RE: Addendum No. **Two (2)** to the Bidding Documents for:  
**NEW Crosby Vehicle Storage Garage, South Portland, ME**

## MTA Crosby\_Addenda Questions - Contract 2021.06 ADDENDUM 2

CONTRACT 2021.06  
 CROSBY VEHICLE STORAGE GARAGE  
 DETAILS - 1

**UTILITY TRENCH - PRIMARY POWER**  
 NOT TO SCALE

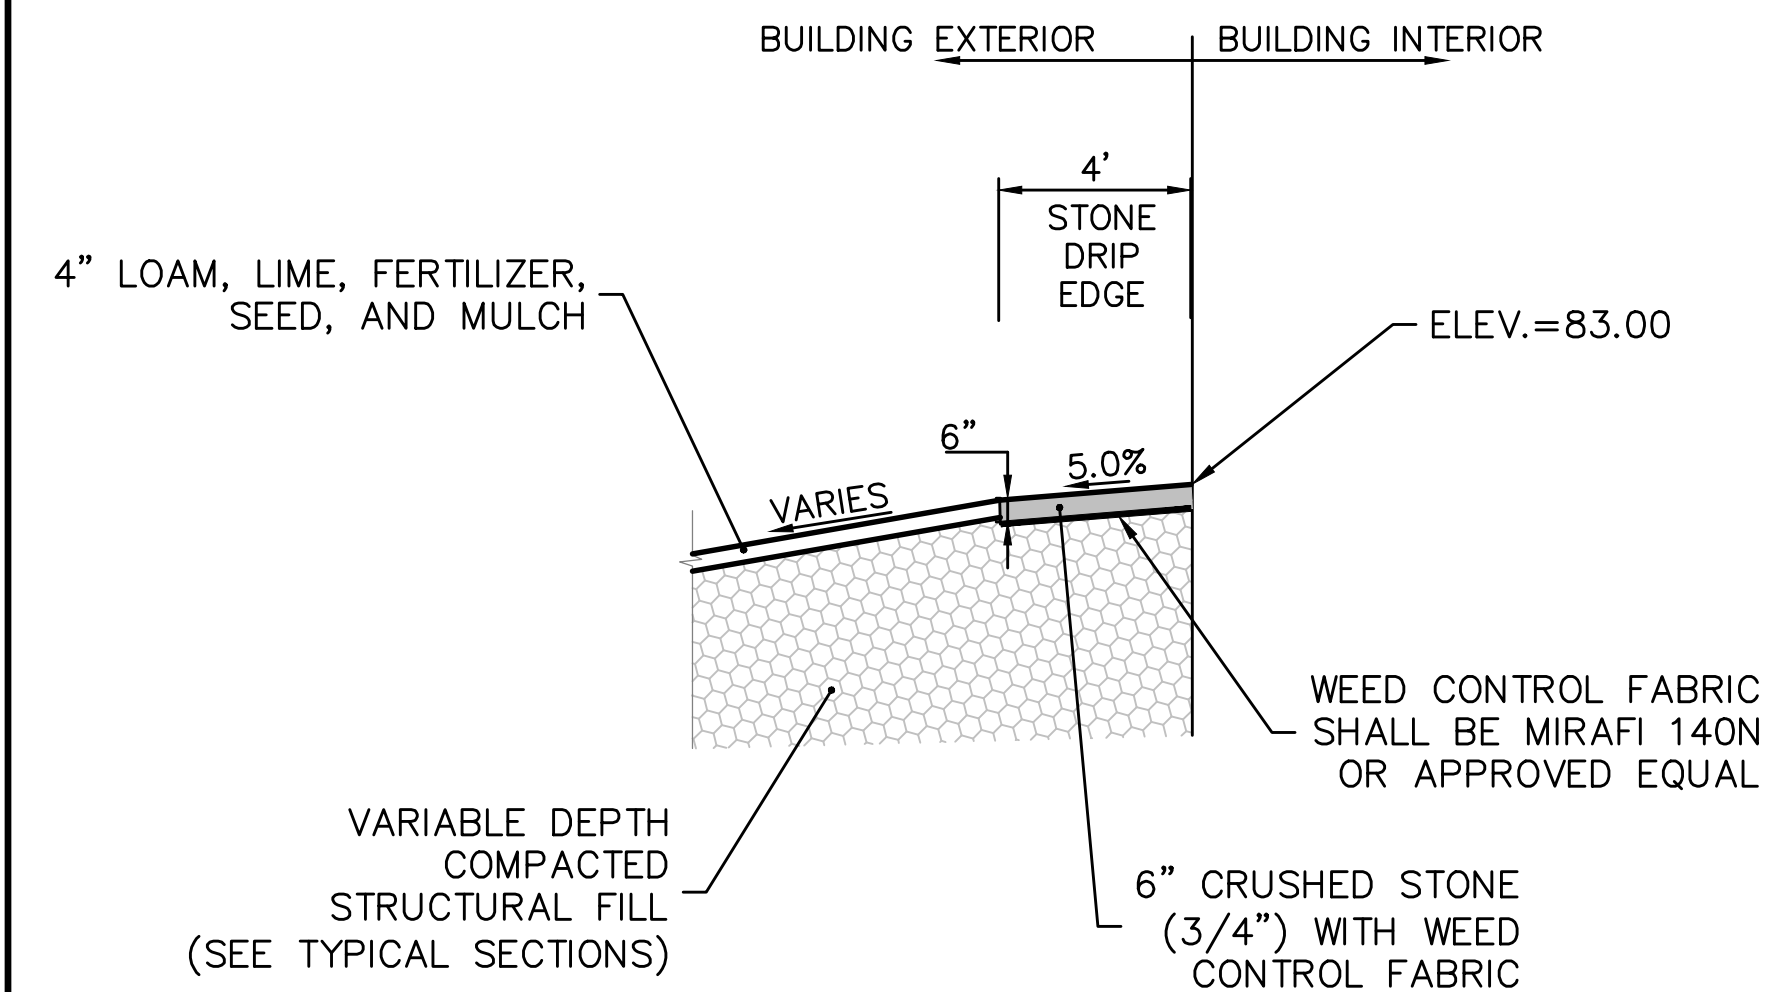
17-Dec-21					
Crosby Vehicle Storage Building					
Contractor/Vendor	Sheet	Plan/Spec	Question	AEI Team Response/Resolution	
1		ES100, EP500, & C401	C401 identifies the primary conduit to be (2) 5", the feeder schedule on E500 identifies the conduit to be a single 4", Please clarify.	<b>G.P:</b> C-401 revised to reflect and match ES100 and ES500. <b>AEI:</b> These 2 schedules are not referring to the same thing. The feeder schedule on the electrical drawings is referring to the feeder from the transformer to the building. The service is overhead so there are no 5" utility conduits for power company wiring. These shall be removed from the civil drawing by addenda	
2	Mancini Electric		C401 identifies two 4" conduits for phone and data, They are not identified within the electrical plans, will the conduits be required?	<b>G.P:</b> C-401 revised to reflect and match ES100 and ES500. <b>AEI:</b> The owner has decided to delete tel com service to the building. The conduits have been deleted by on C-401 this addenda as well as interior tel/data outlets and backboard on .

3			C401 identifies a spare 1 1/2" conduit, where should this conduit be terminated at the building? This is not identified within the electrical drawings.	<b>G.P:</b> C-401 revised to reflect and match ES100 and ES500. Conduit was deleted.	
4			Specification section 260923 Lighting Control Devices, this section refers to lighting controls not identified within the electrical plans provided. Lighting within the space is shown to be operated with standard switching devices. We just want to receive verification automated lighting controls are not required for the interior lighting.	The photoelectric switches referred to in the lighting control devices spec are indicated in the luminaire schedule for the exterior lighting. Interior controls are as shown on the lighting plan.	
5	Blane Casey Building Contractor	Section 011000 - Summary	In Addendum No 1, Summary 011000- page 1 it notes the ceilings are exposed structure – not liner panel as called out on the plans.	<b>AEI:</b> See attached specification section revision 12/17/21_Addendum 2

CONDUIT TYPE SCHEDULE				
SERVICE	CONDUIT SIZE	GRASS & PAVED AREAS	UTILITY	REMARKS
A	2-5"	SCHEDULE 80 PVC ELECTRICAL GRADE	PRIMARY POWER	SEE NOTE

NOTE:  
 PROVIDE GALVANIZED STEEL LONG SWEEP AT RISER POLE AND EXTEND GALVANIZED CONDUIT TO 10" ABOVE GRADE AT POLE WITH STAND-OFF BRACKETS.

A1 MECHANICAL PLAN

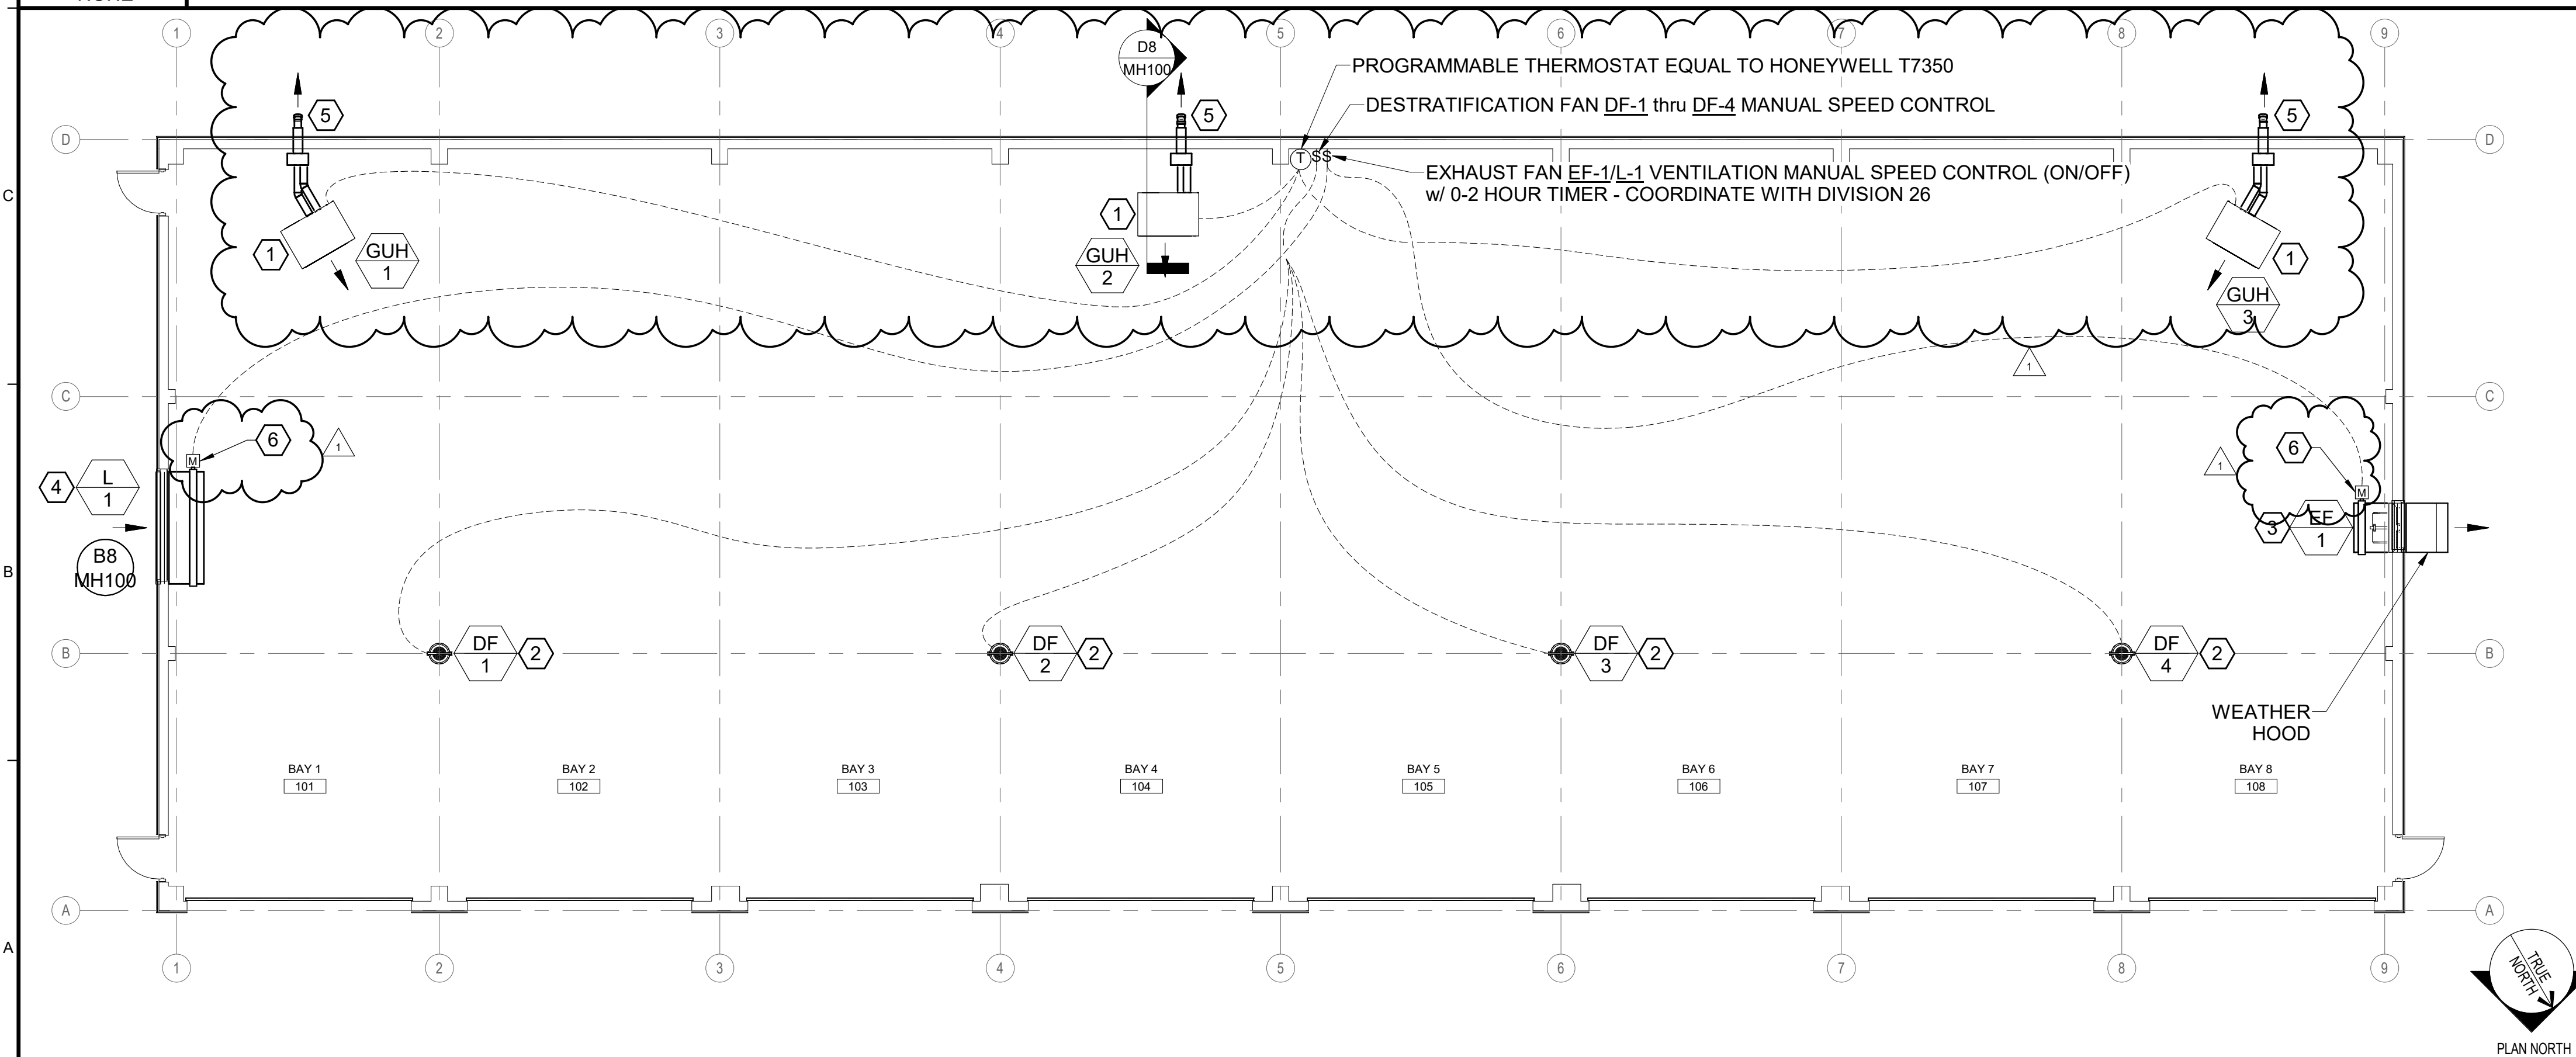
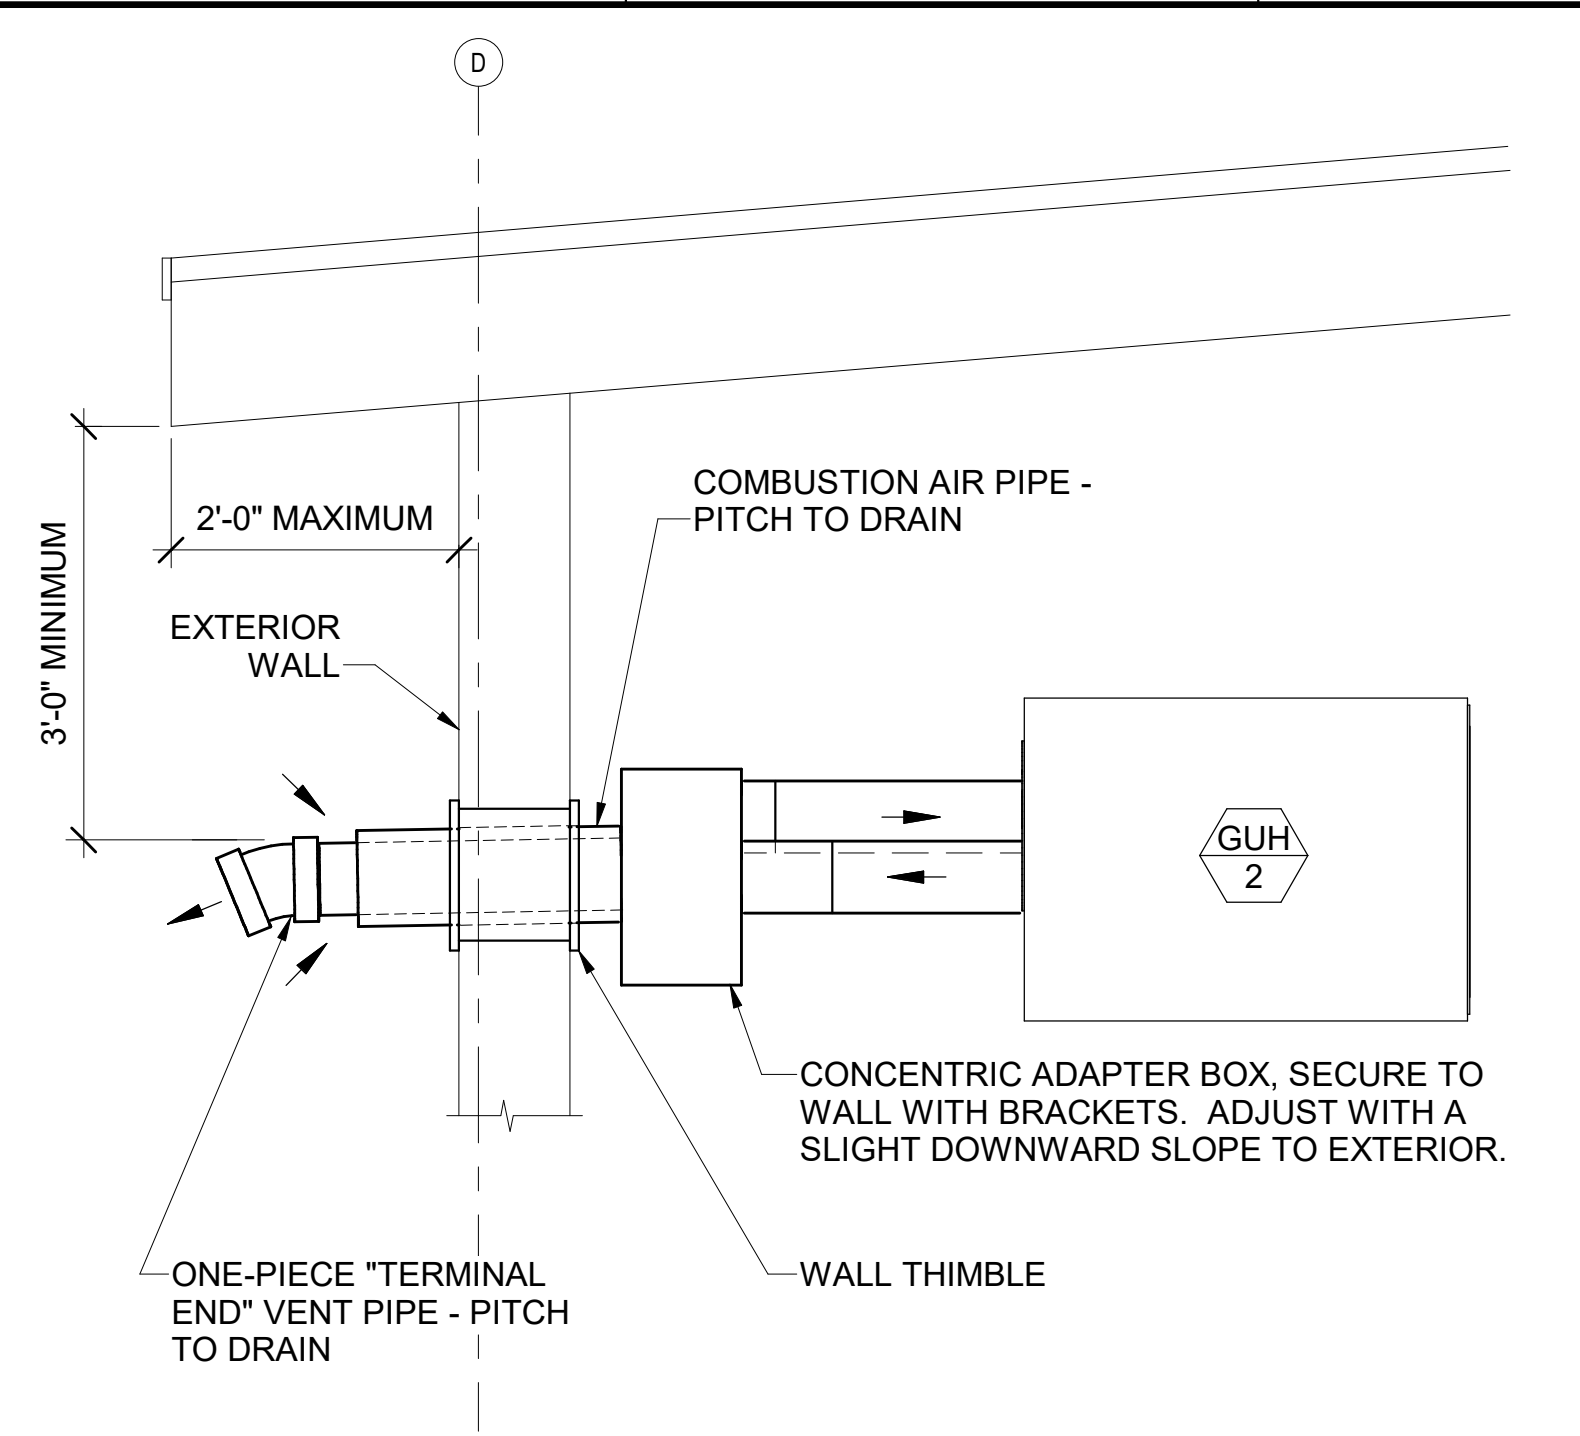
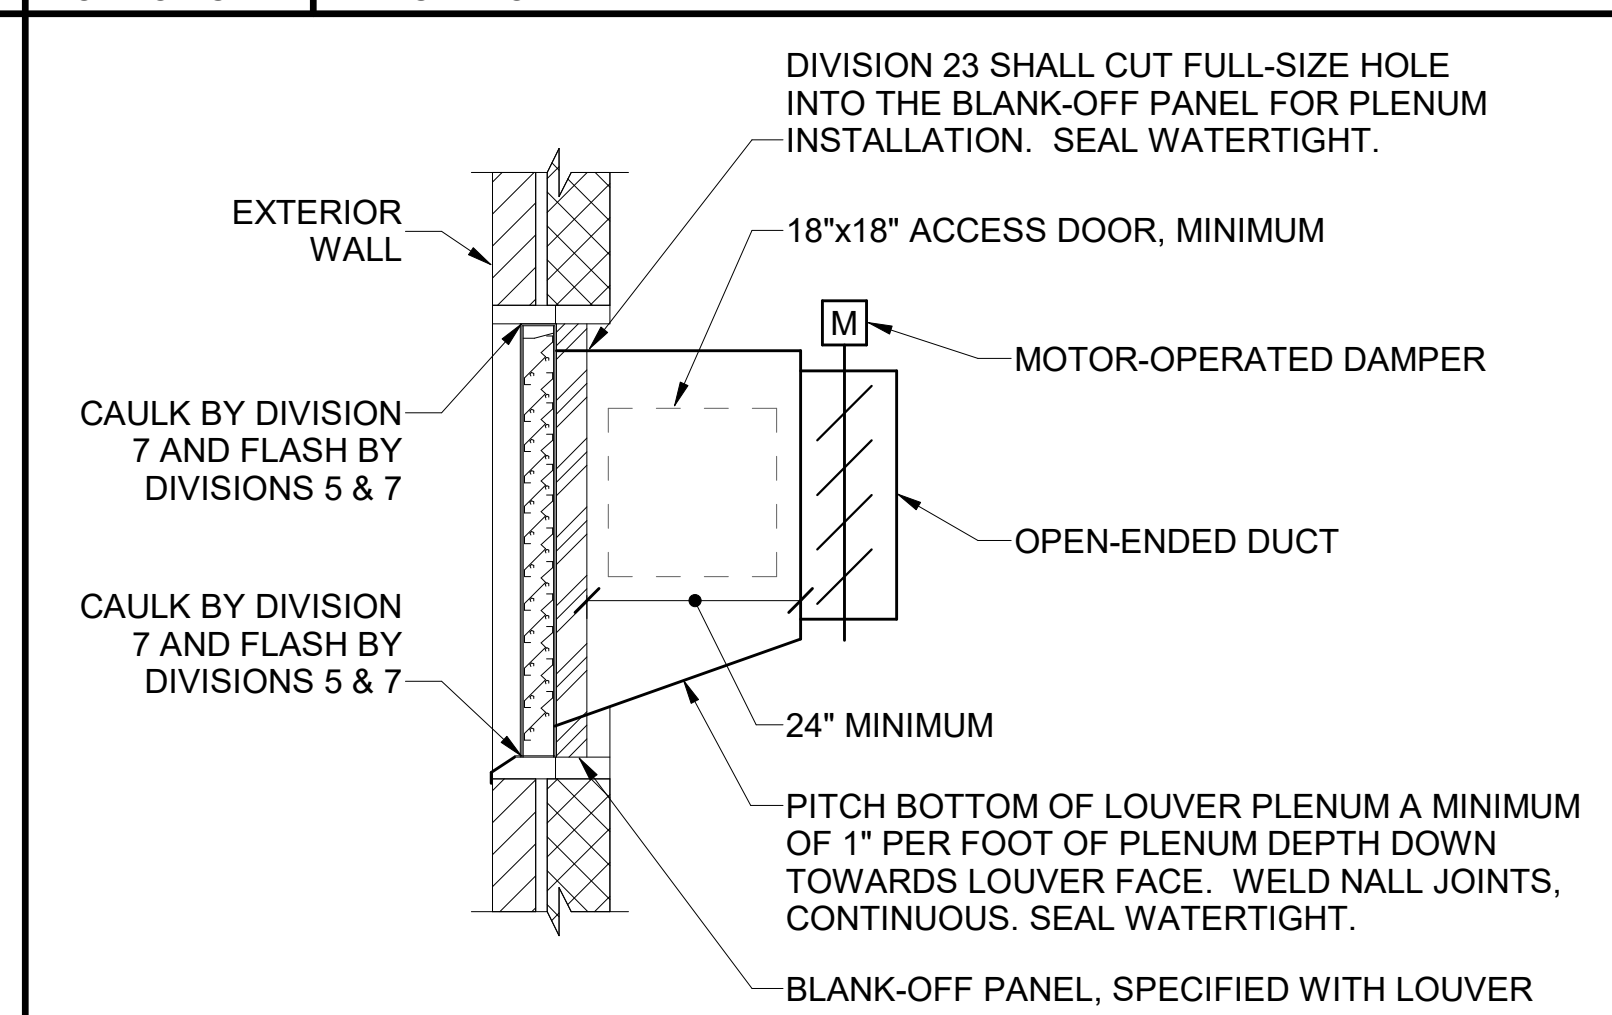
8	Basix Automation Integrators		We are an HVAC DDC controls contractor and we're looking into bidding on this project. We use Schneider controls, and attached with the Substitution Request is an RFQ detailing our work. If you have any questions or clarifications, please let us know.	<b>AEI:</b> A DDC Building Automation System will not be required for this facility. Section 230900 is deleted under Addendum #2.

- ① MOUNT UNIT HIGH AS POSSIBLE, TIGHT TO ROOF STRUCTURE, MAINTAINING MANUFACTURER'S MINIMUM RECOMMENDED CLEARANCES - APPROXIMATELY 13'-0" ABOVE FINISHED FLOOR.
- ② BOTTOM OF FAN = 14'-0" ABOVE FINISHED FLOOR.
- ③ BOTTOM OF FAN = 8'-0" ABOVE FINISHED FLOOR.
- ④ BOTTOM OF LOUVER = 6'-0" ABOVE FINISHED FLOOR.
- ⑤ CONCENTRIC 6" EXHAUST VENT / 8" OUTSIDE AIR VENT THRU EXTERIOR WALL.
- ⑥ LINE VOLTAGE MOD (110V) - COORDINATE WITH DIVISION 26.
